TP2
London School of Hygiene & Tropical Medicine

LEGEND (ALL CHANGES TO ALL LEVELS)

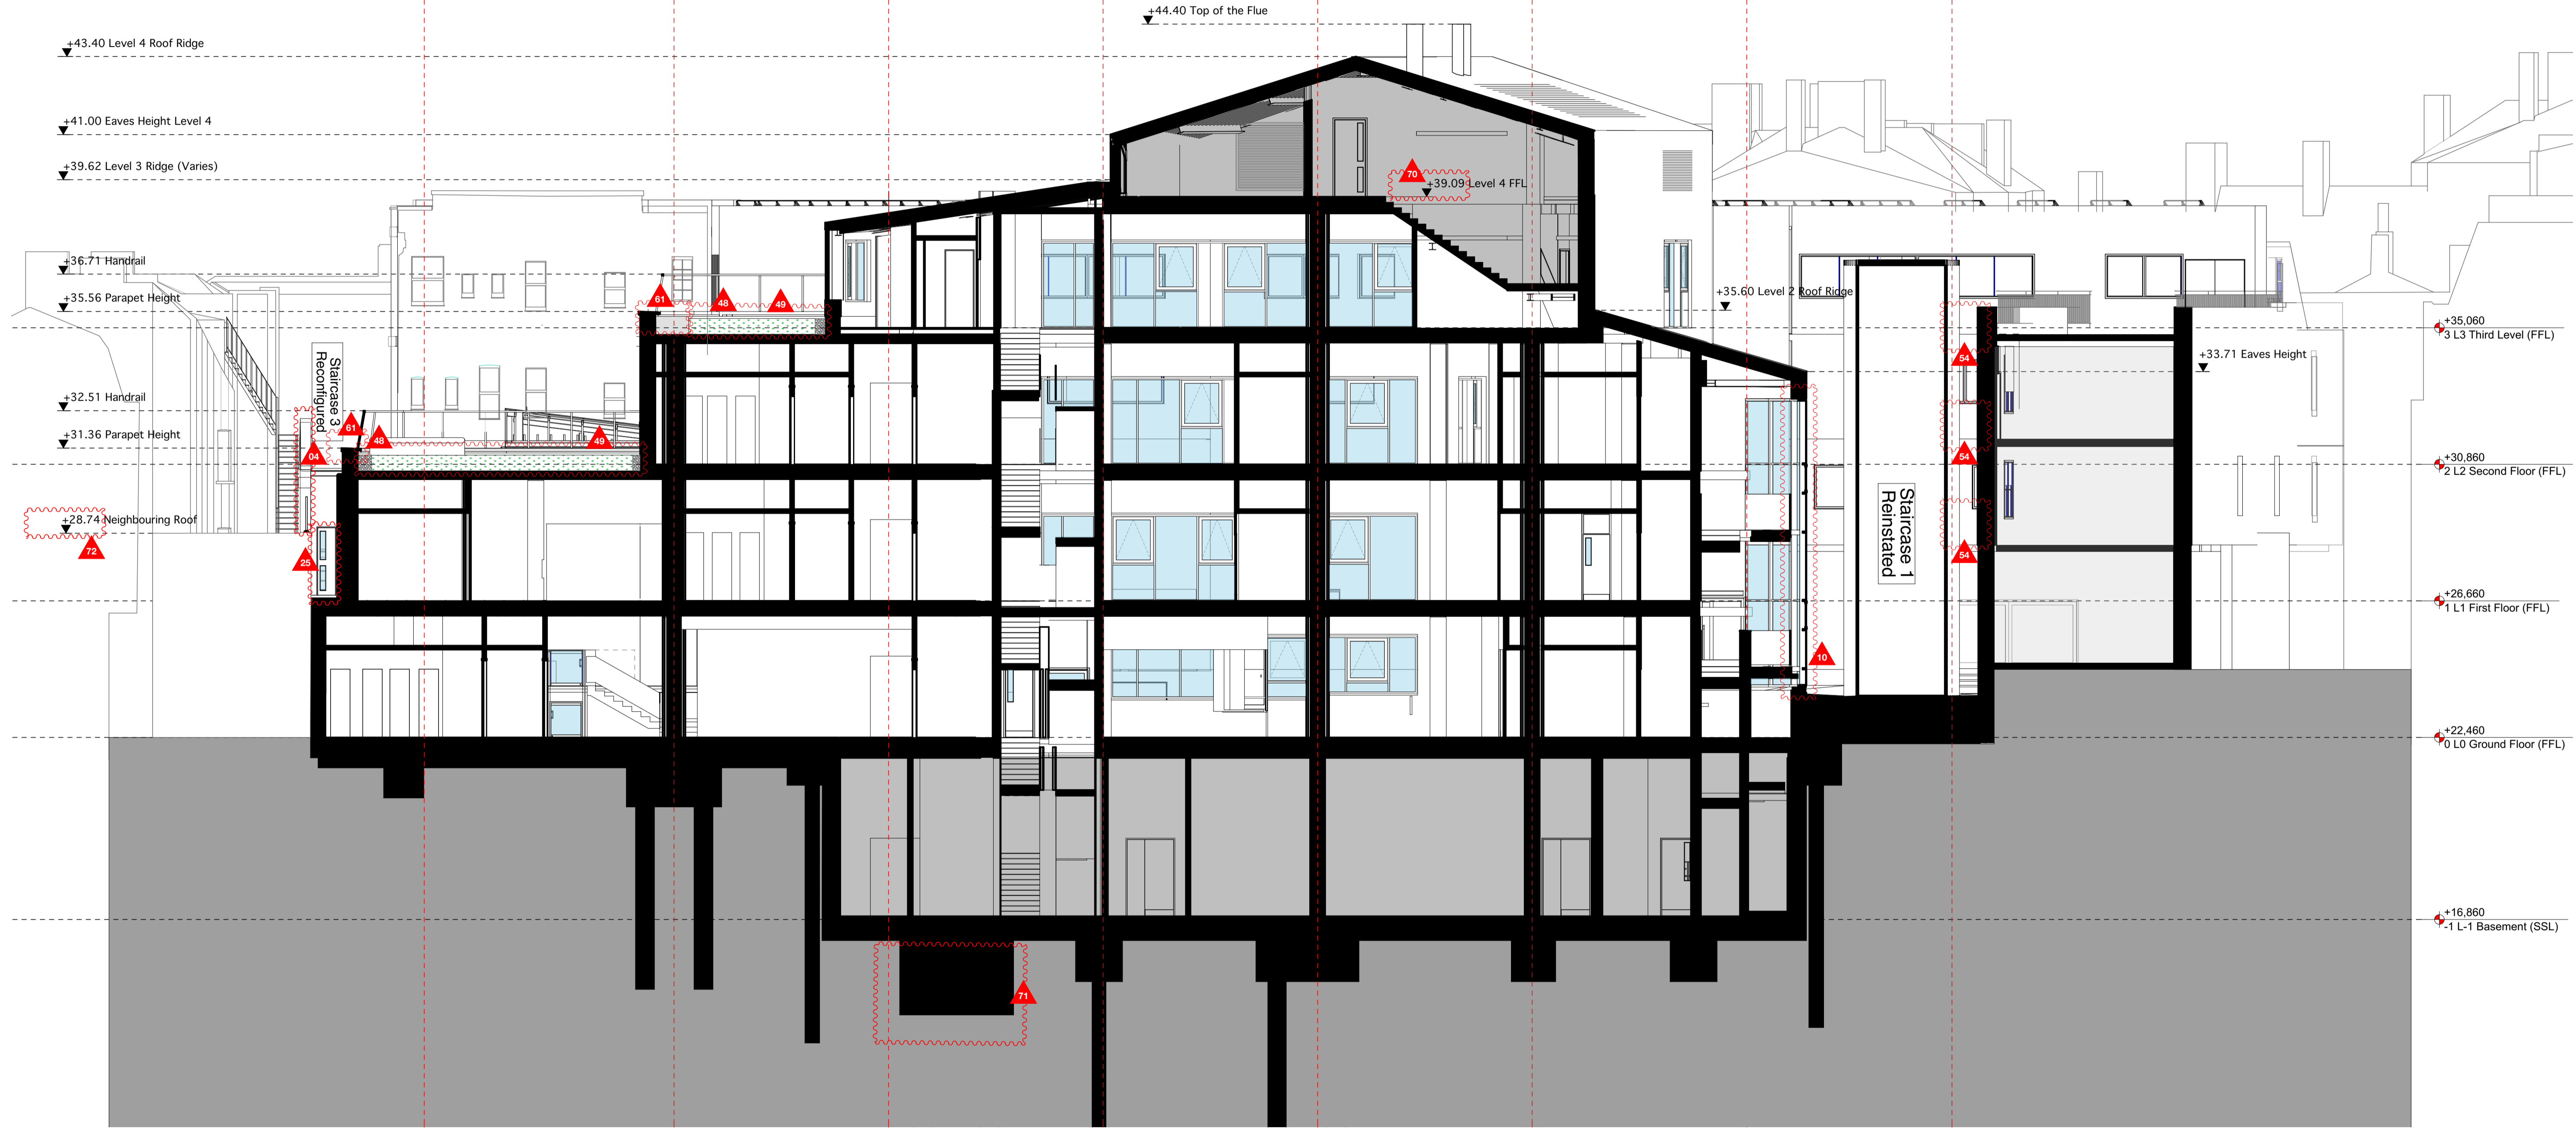
| <ul style="list-style-type: none"> 01 Stair 2 omitted, and glazed entrance enclosure enlarged 02 Window added 03 New steps to base of external spiral stair 04 Stair 3 roof and gable end arrangement revised. 05 Level 3 accommodation mansarded 06 Roof light size, height and position adjusted, and smoke vents added. 07 Louvres omitted. 08 Roof light size, height and position adjusted. | <ul style="list-style-type: none"> 09 External ramp adjusted, and railings added. 10 West stair core glazing fenestration adjusted to suit amended stair landing levels. 11 External paving levels in courtyard raised to achieve required paving falls. 12 Low brick plinth added to base of external walls to TP2. 13 Brick plinth added to base of existing buildings within courtyard. 14 New steps and landing outside room G1. 15 Bin store enlarged and repositioned. 16 Gallery passageway to TP2: finishes revised. 17 Gallery passageway; entrance gates design revised. | <ul style="list-style-type: none"> 18 Window on north elevation of TP2 reduced in length. 19 Revised turn-table size and position 20 Entrance ramp gradient and levels adjusted. 21 External levels adjusted 22 TP1 west door ramp omitted 23 Fall restraint added 24 Gates removed 25 Maintenance access door added 26 Parapet revised 27 Roof/wall shape adjusted 28 TP1 reception relocated | <ul style="list-style-type: none"> 29 Revised door design 30 Modifications to windows, doors and facades facing into courtyard. 31 Gate details revised 32 Revised proposal for bike storage replacing existing bike racks in Dairy shed. 33 Gate retained and modified 34 Bike canopy detail revised (typical condition highlighted) 35 Sub-station doors revised 36 Steps adjusted 37 Cladding changed to brass finish 38 Wall mounted planters revised (typical condition highlighted) 39 Steel posts added to boundary wall (typical condition highlighted) | <ul style="list-style-type: none"> 40 Height of glazed entrance roof increased to suit required pitch. 41 Glazed entrance roof and canopy revised 42 New roof guarding to existing flat roof 43 Screening fins and cladding added 44 Louvres added 45 Ramp omitted 46 Door removed and infilled 47 Access hatch adjusted. 48 Depth of green/blue roof build-up adjusted. 49 Blue roof incorporated into green roof and gravel margins added. 50 Cladding build-up adjusted | <ul style="list-style-type: none"> 51 Orientation of brass seams adjusted 52 Roof gutters revised. 53 Means of escape revisited and exit door added to TP1 54 Spiral staircase landings added at each floor 55 Door modified 56 Basement louvers to external metal staircase landings 57 Revised proposal for mean of escape in TP1 58 Revised proposal for window and door 59 Revised proposal for door to be left as current 60 Gate to be removed 61 Capping width adjusted and roof planters shown indicatively. | <ul style="list-style-type: none"> 62 Door to be replaced 63 Revised proposal for the entrance 64 Gates and Entrance door in TP1 to be replaced 65 Existing stair to be demolished 66 Existing window and door to be replaced 67 New reconfiguration for new spiral stair and WC 68 Staircase partially demolished 69 Level adjusted 70 Lift pit adjusted 71 Level updated 72 Red line extended to include South Crescent Mews | <ul style="list-style-type: none"> 73 Red line extended to include new ramp and frontage 74 Ladder added 75 Works to Mews paving/kerbs added 76 Minor adjustment to ridge, and eaves line, (not affecting ridge level noted on consented drawings). |
